CA Coastal Commission report,
CDP 9-15-0228 Special Condition 7

LA192017-R-001 REV. 1

**INDEPENDENT THIRD-PARTY REVIEW OF SONGS' INSPECTION AND
MAINTENANCE PROGRAM FOR THE HOLTEC ON-SITE INDEPENDENT SPENT
FUEL STORAGE INSTALLATION**

JUNE 12, 2020

Figure 6-2 Metallic Overlay Process for Repairing MPCs at SONGS [1]

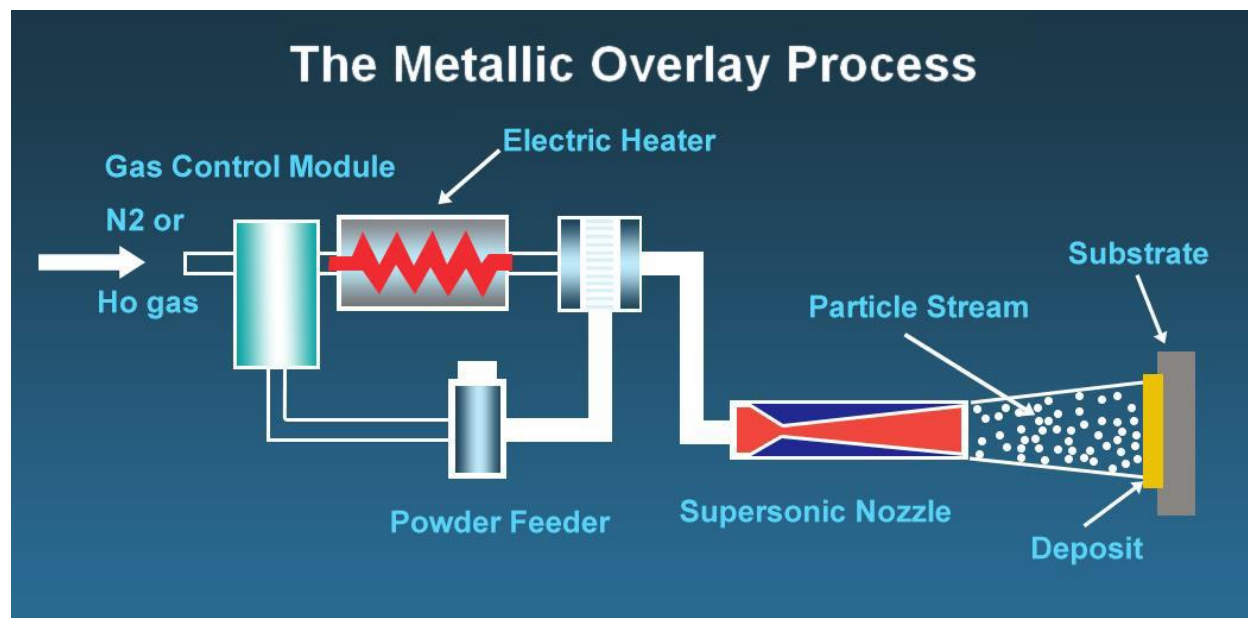
LPI requested clarification on the potential for any adverse effects that result from the metallic overlay methodology, and how the overlay may affect the desired fabrication stresses of the MPC. SCE stated that laboratory tests do not show any adverse effects resulting from application of the metallic overlay process. Instead, the metallic overlay process induces a compressive stress on the base material, which improves the resistance to SCC initiation.

Based on the documentation provided on the metallic overlay process, and SCE's efforts to employ the latest repair methods on degraded MPCs (if it should occur), the proposed repair and mitigation plan for the SONGS Holtec ISFSI canisters is reasonable.

Figure 7-1 Normal Distribution, Three Wear Depth Measurements

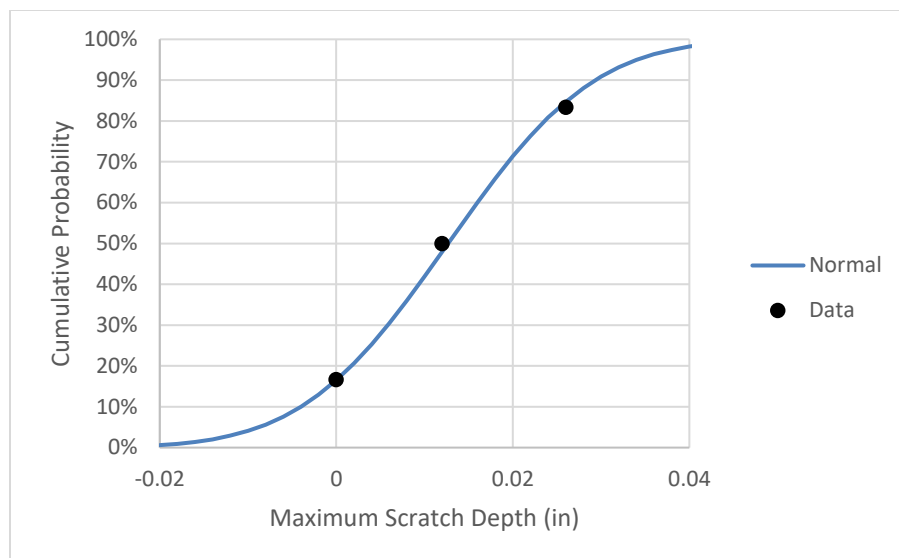
LPI is of the opinion that the Normal distribution is not appropriate to model the maximum scratch depth per canister. In [29], the Normal distribution is based on the initial three measurements of 0.000, 0.012, and 0.026 in., with a corresponding mean and standard deviation (calculated by LPI) of 0.0127 in. and 0.013 in., respectively. In contrast, the Canister Inspection Plan [29] mistakenly reports the mean and standard deviation as 0.013 in. and 0.0125 in., respectively. This was clarified by SCE (as outlined in Attachment G) by conservatively replacing the reported 0.000 in. value with a 0.001 in. value to derive the mean and standard deviation values of 0.013 in. and 0.0125 in., respectively. An LPI plot of the data and fit are shown Figure 7-1.

For the initial three data points shown in Figure 7-1, it is evident that approximately 16.5 percent of the distribution extends into a region of negative or impossible values. If the mean and standard deviation for all 8 measurements had been used, approximately 7 percent of the distribution would still fall below zero. Both sets of data fail the typical “95% range check” [43] for considering the Normal distribution, whereby 95 percent of the fitted distribution needs to make physical sense. Although the primary region of concern is the upper tail of the distribution, specifically at 0.0625 in., having a significant amount of probability assigned to physically impossible negative values deprives the larger maximum scratch depths of probability, thereby underestimating the true risk to the canisters.

In summary, it was recommended the statistical analyses be updated at this time using a more appropriate distribution method, this was done by SCE, as outlined in Attachment G. Additionally, it is recommended that the statistical evaluation be reassessed after the scheduled 2024 MPC inspections, and every time MPCs inspections are performed thereafter to incorporate the additional wear depth data. The revised statistical analyses should include all wear depth data, and employ extreme value statistics to predict 95 percent probability bounding flaw depth, with 95 percent confidence level for the entire MPC population and not just a single canister. The number of canister inspections and inspection frequency should be revised (as appropriate) based on the revised statistical analyses. Scratch depth data from future inspections will likely reduce the probability in a meaningful way provided, of course, that the maximum scratch depths stay within the range of previous depth measurements.

Figure 4-1.

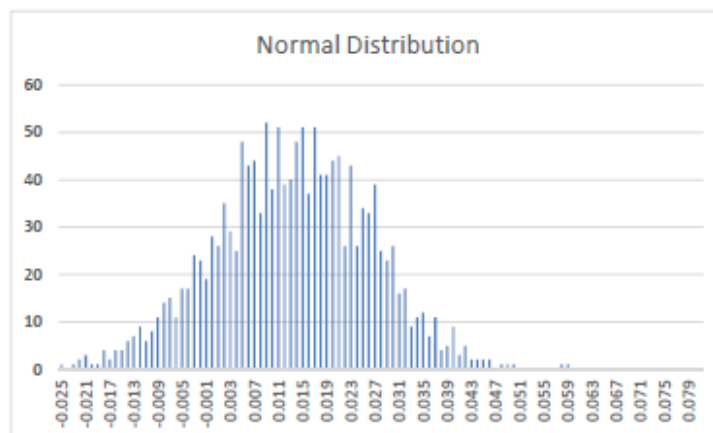
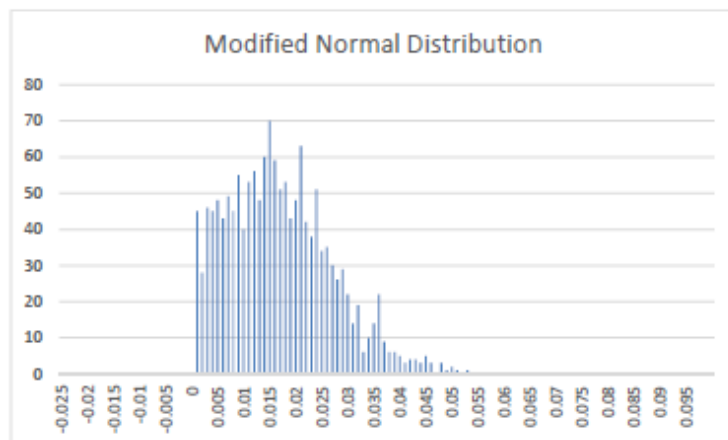
One concern with selecting a normal distribution for modeling the deepest scratch random variable is that measured scratch depth is always a positive number and the left tail of the normal distribution will include some negative numbers making the probabilities associated with a standard normal distribution non-conservative. To determine whether use of a standard normal distribution is acceptable considering the effect of the negative left tail values, a simulation was run using 1500 trials to produce a modified normal distribution that forces all scratch depth measurements to be positive numbers. In the simulation, every time a negative value for scratch depth occurs, the simulation selected another normally distributed random number to replace the negative value until a positive value appeared. The results of simulations for the standard normal distribution and the modified normal distribution for the mean scratch depth (13 mils) and standard deviation (12.5 mils) associated with the three measured canisters are compared below.

As described in the attached April 15, 2019 MPR white paper, *Canister Inspection Plan*, the concern that assuming a normal distribution would be non-conservative since a normal distribution would allow negative scratch depths, was previously addressed by performing a sensitivity analysis that showed the effect of the slight non-conservatism introduced by the negative values in the left tail of the normal distribution did not have a significant effect on the maximum scratch depth statistics.

Figure 2 – Canister #72 Detailed Pictures and Profilometry

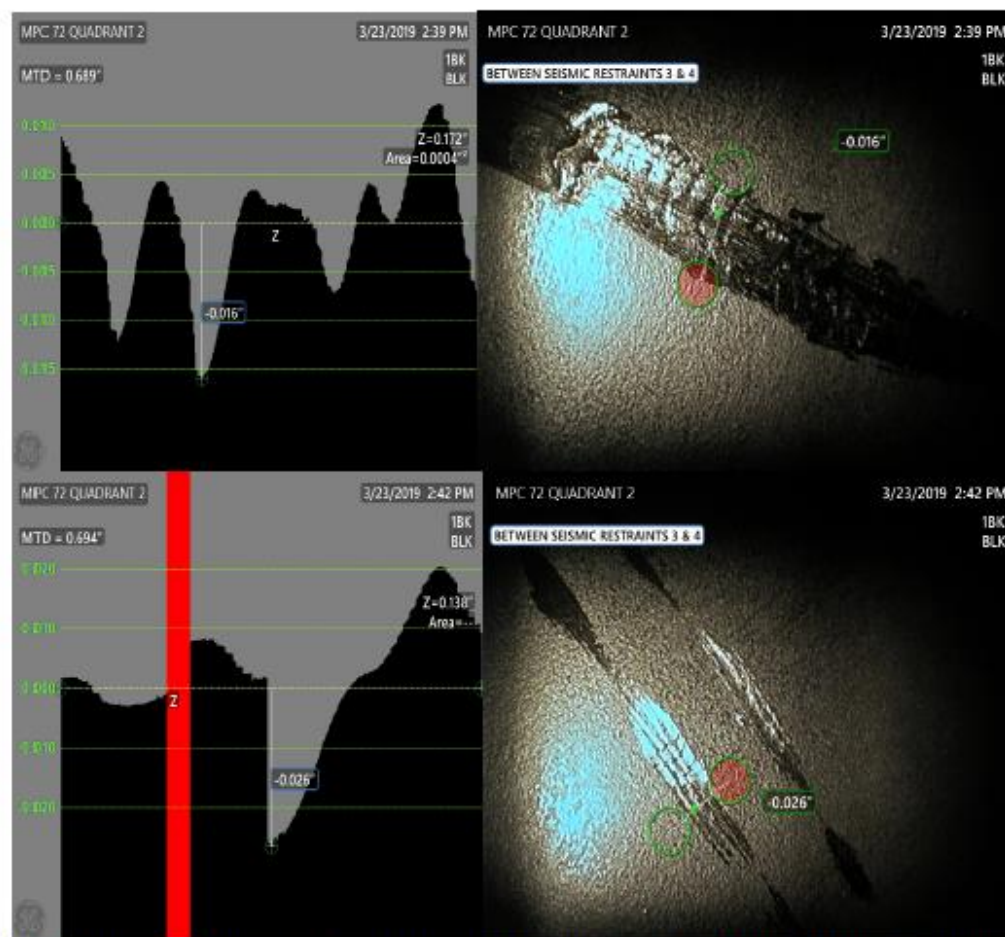
- 1) Please provide more information regarding the 2019 canister inspections, MPC scratch profiles, and number and location of scratches.

As an example, representative photos of two scratches from canister #72, with associated profilometry, are shown in Figure 2 below. (These scratches are identified in the highlighted entries of Table 1 above.) Both of these scratches were caused by interaction with a seismic restraint.

The profiles generally show raised metal adjacent to each depression consistent with galling of austenitic stainless steel. No metal removal was observed. No metal debris was found in the bottom of the VVM or at the contact points on top of the shield ring or seismic restraints.

The deeper measurements were only observed in localized areas of galling. Galling occurs when two austenitic stainless steel surfaces wear, and is a different phenomenon than the scratching modeled by the FEA. Galling is self-arresting because the material is not removed, just rearranged.
